Overview: Production error; immobilizer wire (orange/black) in pin position #4 instead of pin position #5. Although an effort to correct the issue was made, some quantity of harnesses did get shipped before the issue was spotted. We are advising to inspect the harness BLADE connector before attempting to install the harness and program the module.

Overview: The FTI-STP1 harness may require modification for use in **automatic transmission (AT)** applications, some of the product was able to be modified before release, but a small quantity was released before being able to be modified internally.

FTI-STP1: Installation and Configuration Notes

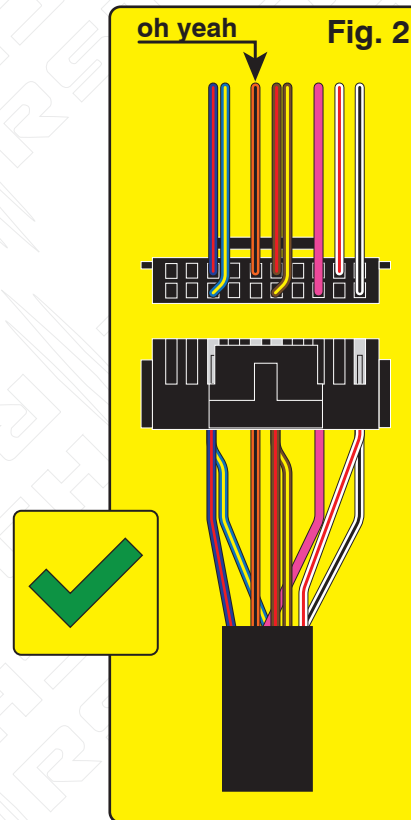
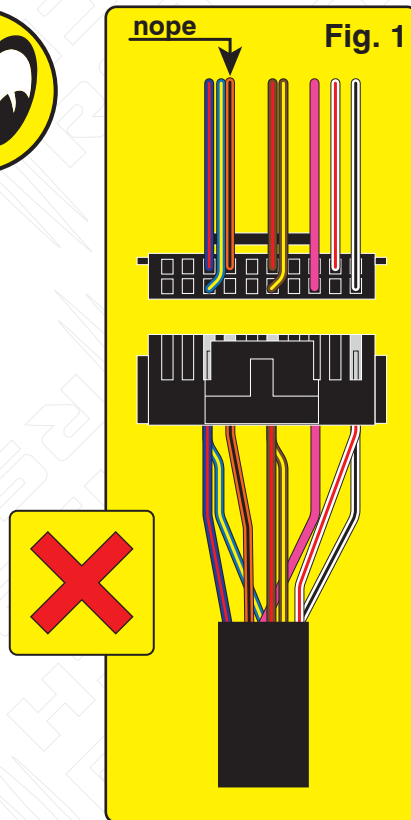
Issue: Module fails to program to vehicle, will not allow the vehicle to be remote started.

Correction: Step 1.) Locate the orange/black wire and confirm whether it is positioned as illustrated in Fig. 1 or Fig. 2. If the wire is as illustrated in Fig.1, proceed with Step 2 through 5 and complete the repair procedure outlined, if the wire is as illustrated in Fig. 2, correction is not necessary, proceed with harness installation and module programming.

Step 2.) Using a pick, lightly depress the catch that secures the terminal in the housing then remove the wire and terminal from the housing.

Step 3.) Using a fine tip razor or utility knife, insert the blade beneath the terminal catch and raise it slightly, so that it can be reused to secure the terminal when reinserted into the BLADE connector housing.

Step 4.) Refer to Fig. 2 for correct position of the orange/black wire (next to brown/red) then reinsert the terminal, pressing lightly until the catch 'snaps' into place, securing the terminal in the connector housing.

MODIFICATION REQUIRED FOR AUTOMATIC TRANSMISSION APPLICATIONS ONLY

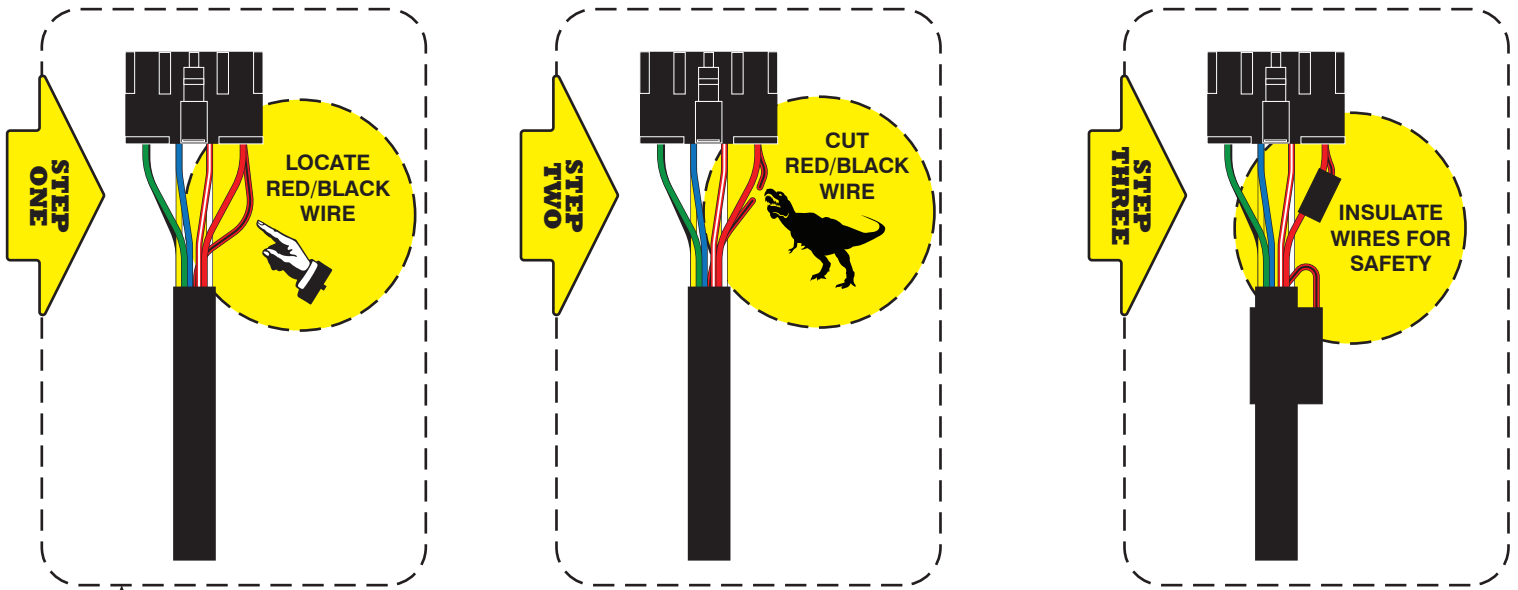
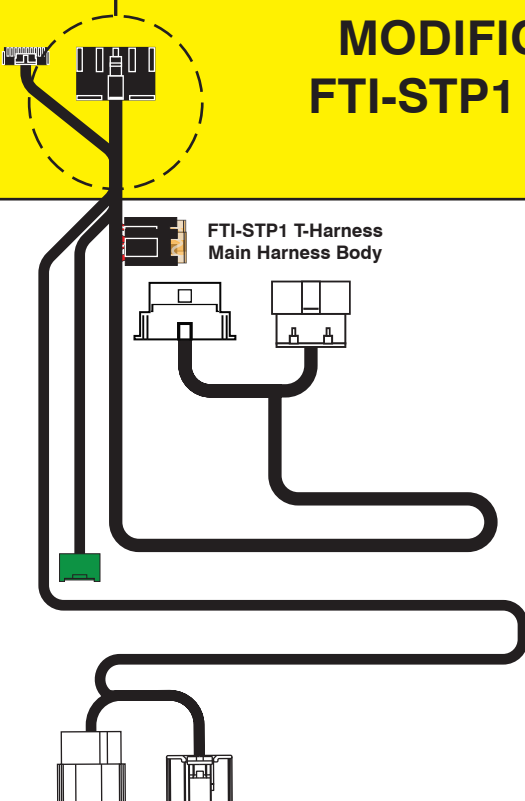
Issue: The FTI-STP1 T-harness has been designed to be compatible with AT (automatic transmission) & MT (manual transmission) applications, but due to a production oversight, the selection mechanism was defaulted to MT mode.

Using a harness configured for an MT application, in an AT equipped vehicle, could result in vehicle module damage, it is advised that the harness be returned to AT mode before installation in vehicles equipped with an automatic transmission.

Correction: Locate the **red/black (+ Clutch)** wire provided in the CN1 connector of the main harness assembly. Cut the **red/black** wire, either flush to the CN1 connector, or leaving enough wire exposed so that you can insulate and secure the ends of the wire that remain after cutting. Insulate each of the remaining ends of the **red/black** wire and secure to prevent any possibility of a short circuit.

If the red/black wire already been disconnected, no further modification is required for AT equipped vehicles.
